## ORIGINATION FORM

Proposed Revisions to a Standard Plans Index  
(Please provide all information — Incomplete forms will be returned)

Index Number: 700-020  
Sheet Number (s): 2 of 3  
Index Title: Multi-Column Ground Sign

Sheet 2: Changed "Class I" to "Class II" in the FOUNDATION Detail.

**FOUNDATION AND BASE CONNECTION DETAILS**

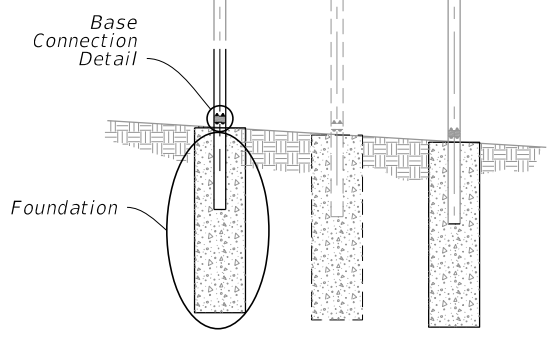
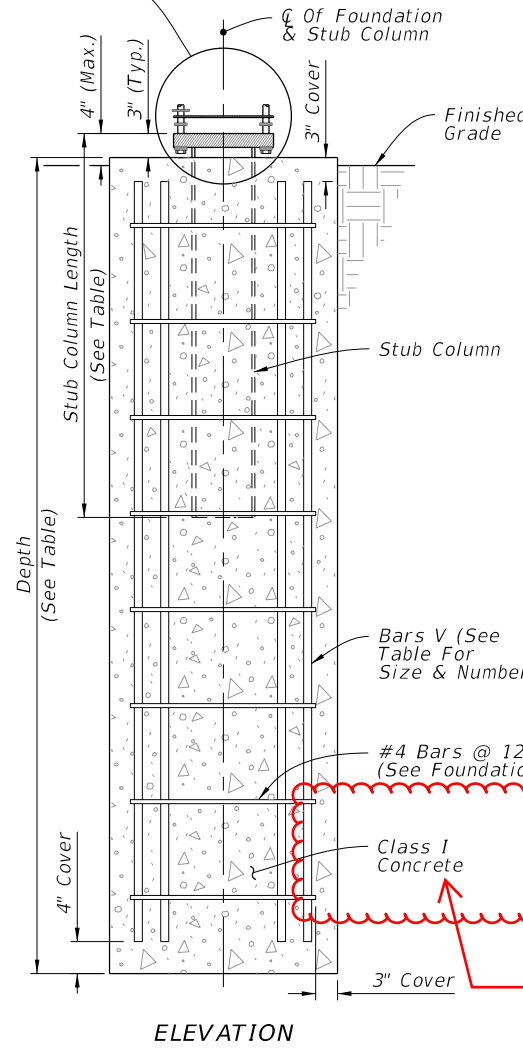
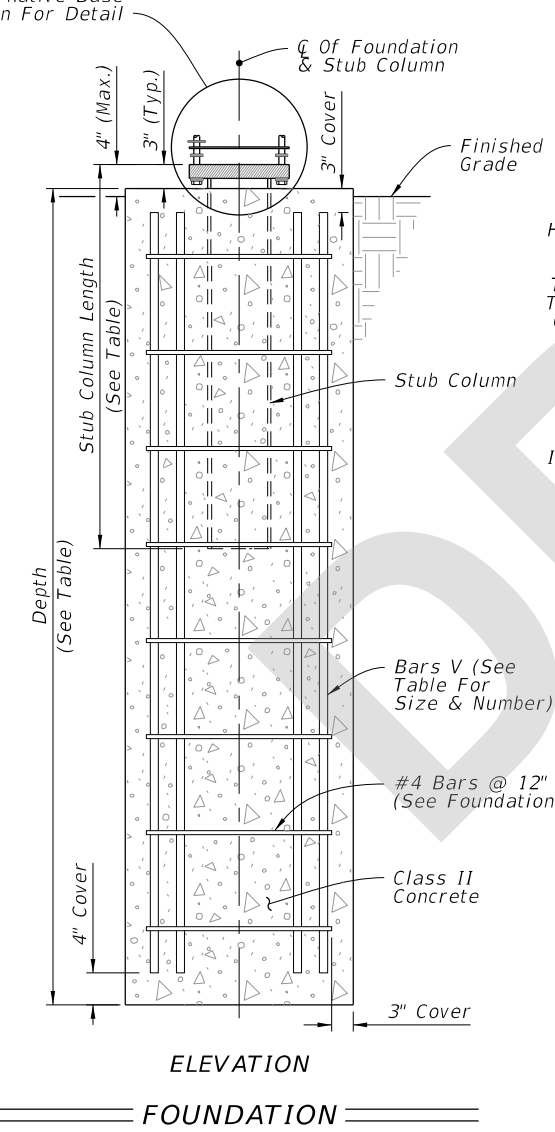
Changed to reflect Materials specification change that removes the designation for Class I Concrete.  
Please see the attached Standard Specification Section 346 DRAFT for the Class I revisions proposed by the State Materials Office.

**CHANGED TO: Class II**
